Access Compliance Report

Public Rights-of-Way

(Curb Ramps)

Intersection ID: 53351	Main Street: MARVIN_RD	Cross Street: SAPPHIRE_HILL_LN	Location: SW
ADA ID: 040A1E241E77	Ramp Type: Perp	Initial Pass/Fail: Fail	Overall Compliance: No
		Severity Score: 8.75

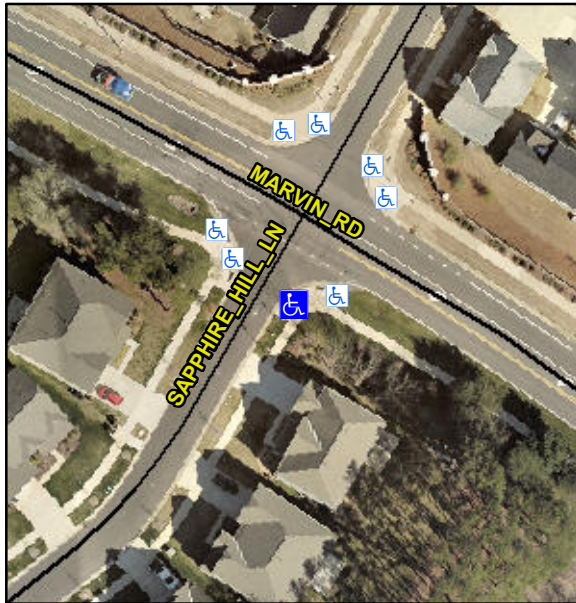
R304.5.1

Compliance	Description	Data	Compliance	Description	Data
N/A	Ramp Length (in)	101.0	Yes	Ramp Slope (%)	5.9
No	Ramp Width (in)	47.0	Yes	Ramp XSlope (%)	1.4
N/A	Flare Type LT	N/A	N/A	Flare Type RT	N/A
N/A	Flare Slope LT (%)	N/A	N/A	Flare Slope RT (%)	N/A
N/A	Flare Traversable LT?	N/A	N/A	Flare Traversable RT?	N/A
N/A	Landing Length (in)	N/A	N/A	DWS Provided?	N/A
N/A	Landing Width (in)	N/A	N/A	DWS Contrast?	N/A
N/A	Landing Slope (%)	N/A	N/A	DWS Length (in)	N/A
N/A	Landing X Slope (%)	N/A	N/A	DWS Full Width?	N/A
N/A	Landing Curb? (Y/N)	N/A	N/A	DWS Offset (in)	N/A
N/A	Shared Landing?	N/A			
N/A	Gutter Ponding?	N/A	N/A	Gutter Slope (%)	N/A
N/A	Gutter Lip Ht (in)	N/A	N/A	Gutter X Slope (%)	N/A
N/A	Painted X Walk1?	No	N/A	Painted X Walk2?	N/A
	X Walk 1 Direction	To NW		X Walk 2 Direction	N/A
N/A	X Walk 1 Width (in)	N/A	N/A	X Walk 2 Width (in)	N/A
	X Walk 1 Slope (%)	2.9		X Walk 2 Slope (%)	N/A
	X Walk 1 X Slope (%)	2.3		X Walk 2 X Slope (%)	N/A

Remove & Replace Entire Ramp.
